RE: Docket 5209 - Proposed FY 2023 Electric Infrastructure, Safety, and Reliability Plan Responses to Data Requests - Division Set 4

Division 4-1

Regarding the 3763 Line Structure Replacements project (Section 2, page 48):

Anomaly: 30

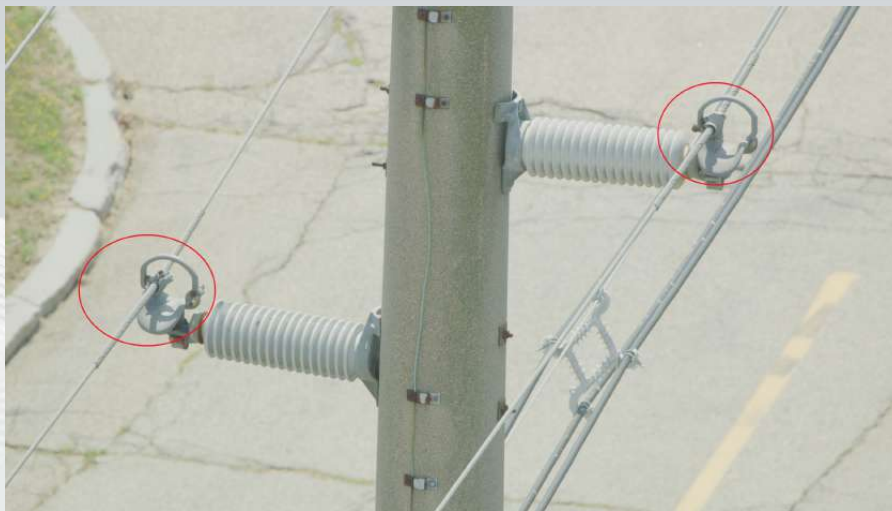
Anomaly Rating		Anomaly Description				Anomaly Type	
3		The top of the concrete pole is damaged.				Visual	
Circuit	3763	Location	3763_STR55_2030378	GPS	41.537591 -71.310091	Inspector Date	Darin McMaster Jul 26, 2020

Anomaly: 35

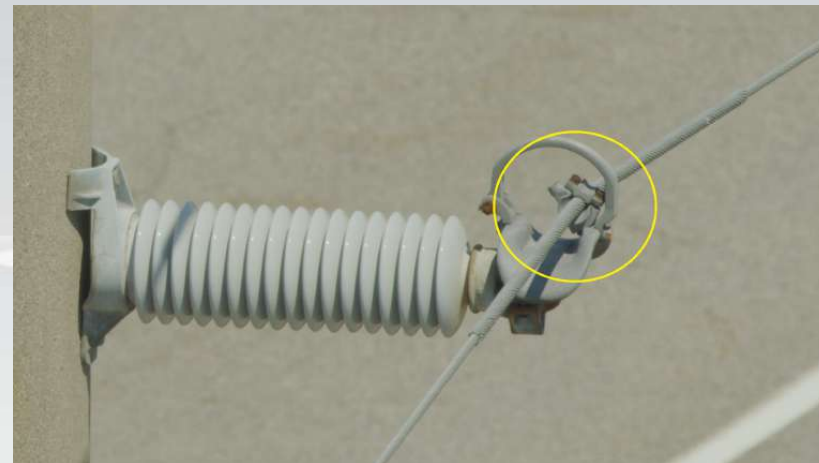
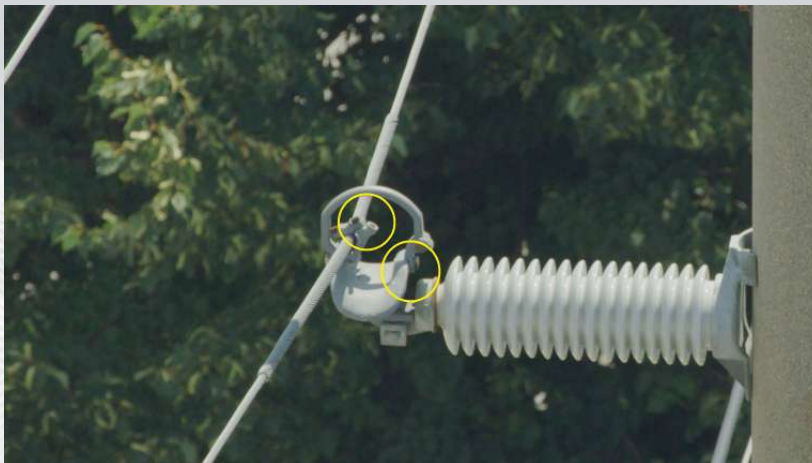
Anomaly Rating		Anomaly Description				Anomaly Type	
2		The SPAC distribution suspension hardware has a hot line type fitting that is not screwed closed on the suspension eye bolt.				Visual	
Circuit	3763	Location	3763_STR61_2030402	GPS	41.533572 -71.312585	Inspector Date	Darin McMaster Jul 26, 2020

Anomaly: 38

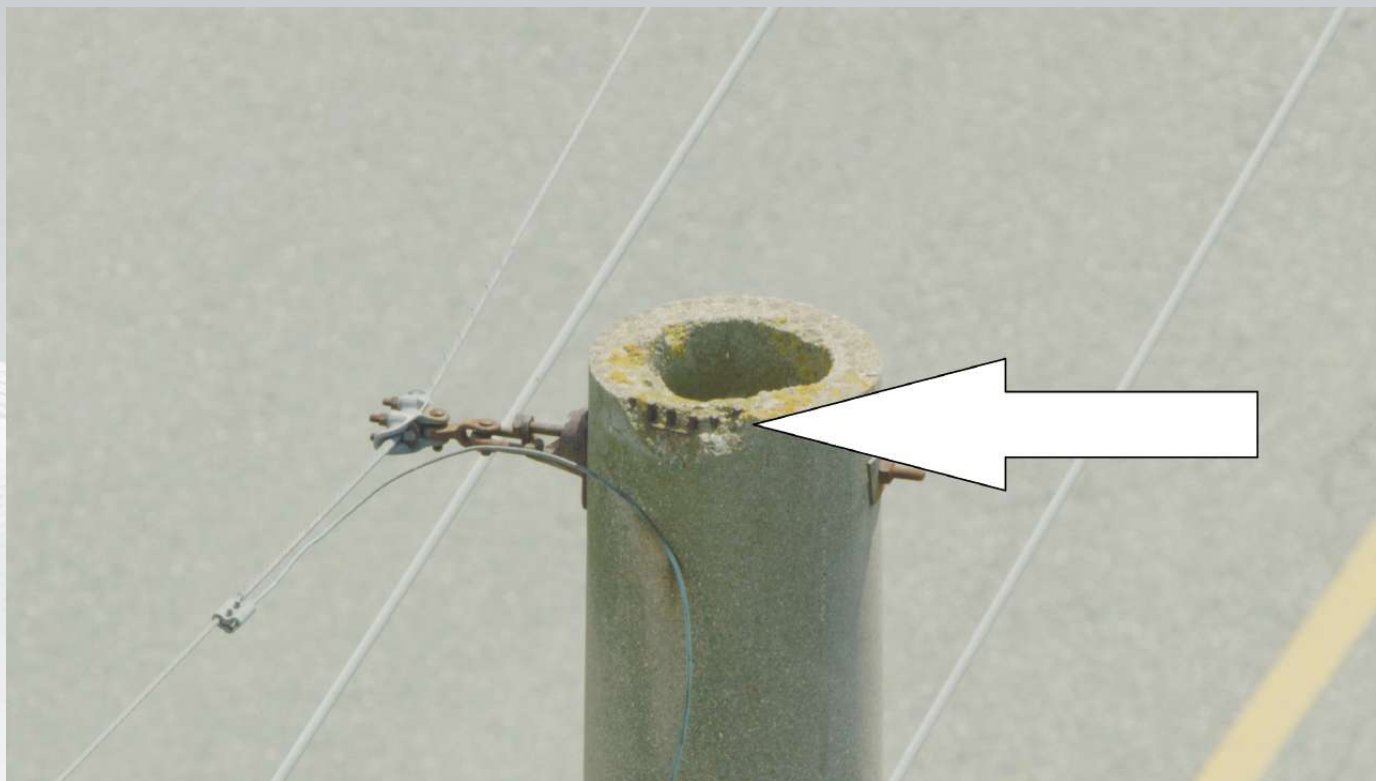
Anomaly Rating		Anomaly Description				Anomaly Type	
3		The pole top concrete is damaged.				Visual	
Circuit	3763	Location	3763_STR63_2030410	GPS	41.531947 -71.312603	Inspector Date	Darin McMaster Jul 26, 2020

Anomaly: 39

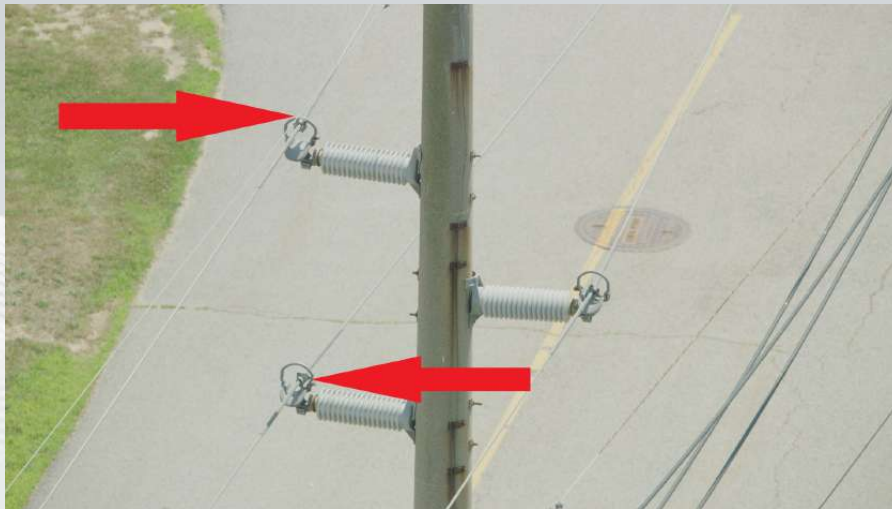
Anomaly Rating		Anomaly Description				Anomaly Type	
2		The conductor clamp trunnion saddle bolts have let go and the wire is loose but trapped inside a retainer ring on the bottom left and top left phases.				Visual	
Circuit	3763	Location	3763_STR64_2030414	GPS	41.531164 -71.312385	Inspector Date	Darin McMaster Jul 26, 2020
